Planning Board Report
Nuance Dental at 233 Route One
Final Plans for Building & Lot Plan & Major Site Plan
Cone Cladicals, LLC, Applicant
Map 31 Lot 25; CD4-C Route One Corridor
Prepared by Erin Zwirko, Director of Planning and Development
Report Date: October 19, 2023; Planning Board Date: October 25, 2023

The applicant previously provided elevations of the Phase 1 building in the application materials:

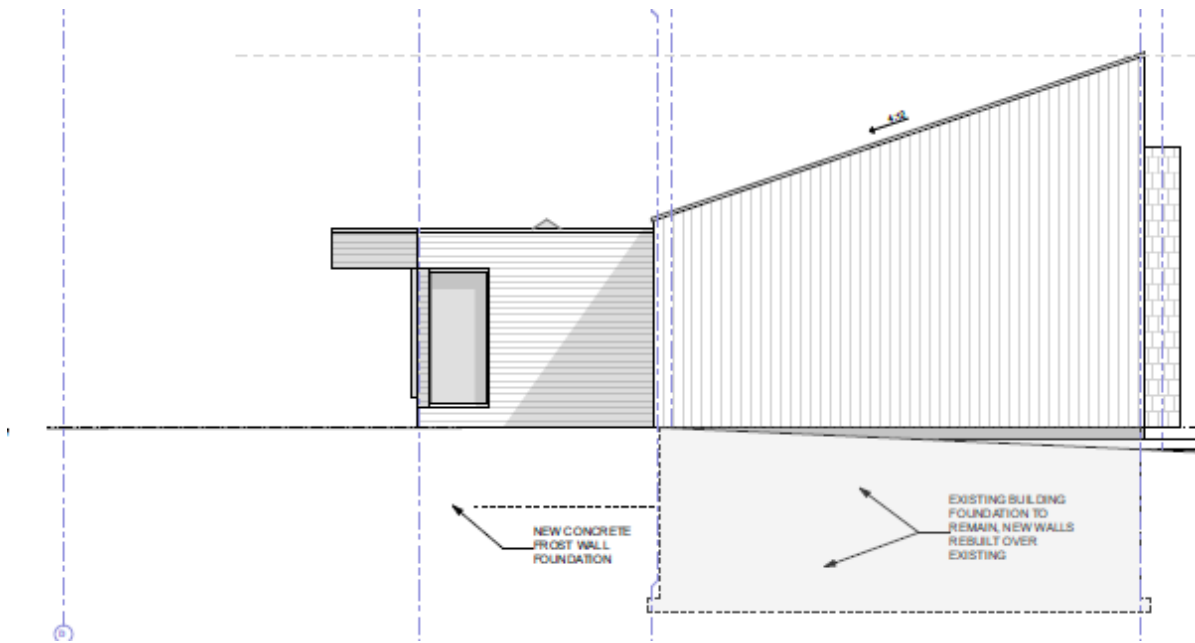
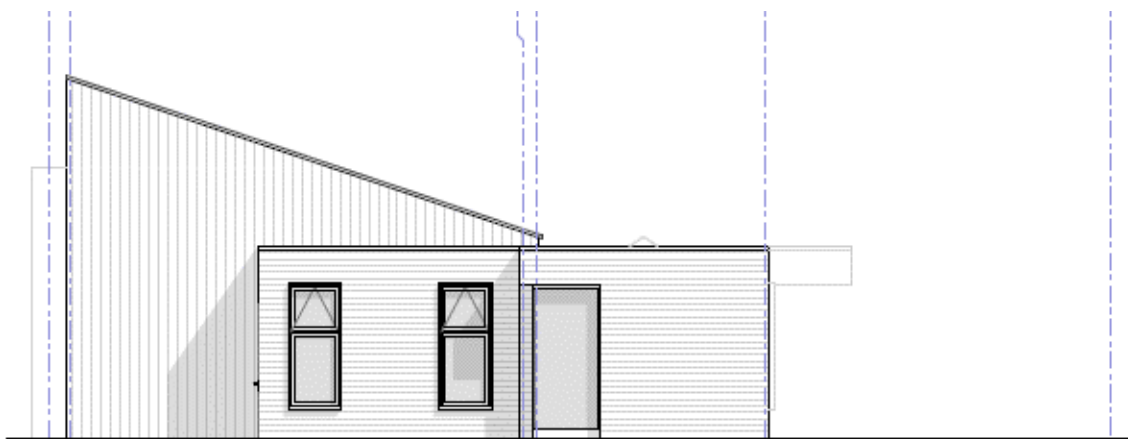
The applicant did identify a waiver for the use of bay windows without a foundation. The applicant indicates that the proposed bay windows (at the rear of the building) are designed to be in character with the building's design and to minimize rework to the existing foundation and are supported by the floor structure. Further, no muntins are being used consistent with the contemporary design of the building.

The applicant indicates that the design team has taken a holistic approach to the design of the building, with the use of a shed roof establishing the framework. The combination of larger, more contemporary windows, without muntins, are complementary to the overall goal of providing greater ambient light and view corridors. The bay windows are consistent with the building's design and minimize the work required to the existing foundation. The bay windows will be supported by extending the floor framing.

As requested by the Planning Board, the applicant prepared a study of different roof lines that were tested in the development of the proposed project:

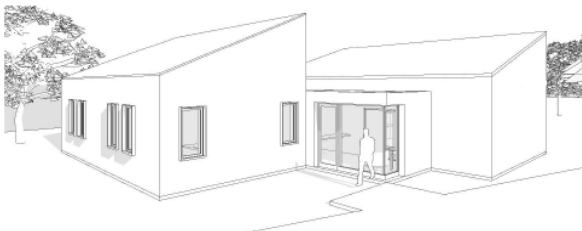
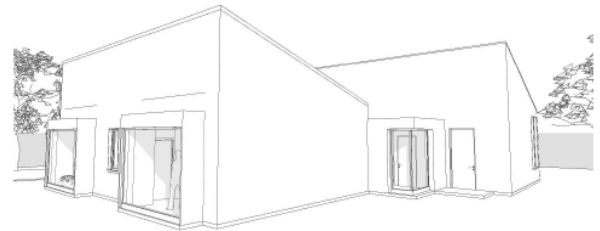
The applicant is proposing a shed roof. The applicant completed the architectural matrix and noted the advantage of the shed roof is that affords greater access to ambient, indirect light to the proposed operatories and the photography studio. The slope of the roof is 5:12 and can be approved with a waiver.

The applicant notes that the shed roof shape allows for a lower wall height at the street facing side of the building while allowing for a higher wall height and larger window openings at the back (lawn facing) side of the building. The reduced slope of the shed limits the height of the building while providing for the operational needs of the building's programming. The applicant notes that it is the least adjustment reasonable to satisfy the operational needs of the project and will have the least impact from the public frontage.

The staff note that the full build out is shown in the graphics above yet note that an approval would only be for the Phase 1 project. However, in full disclosure of the full build out anticipated, the applicant illustrates what the building would look like at completion. The Staff recommend approval of this waiver and note that the approval of the shed roof will drive the architecture of Phase 2.
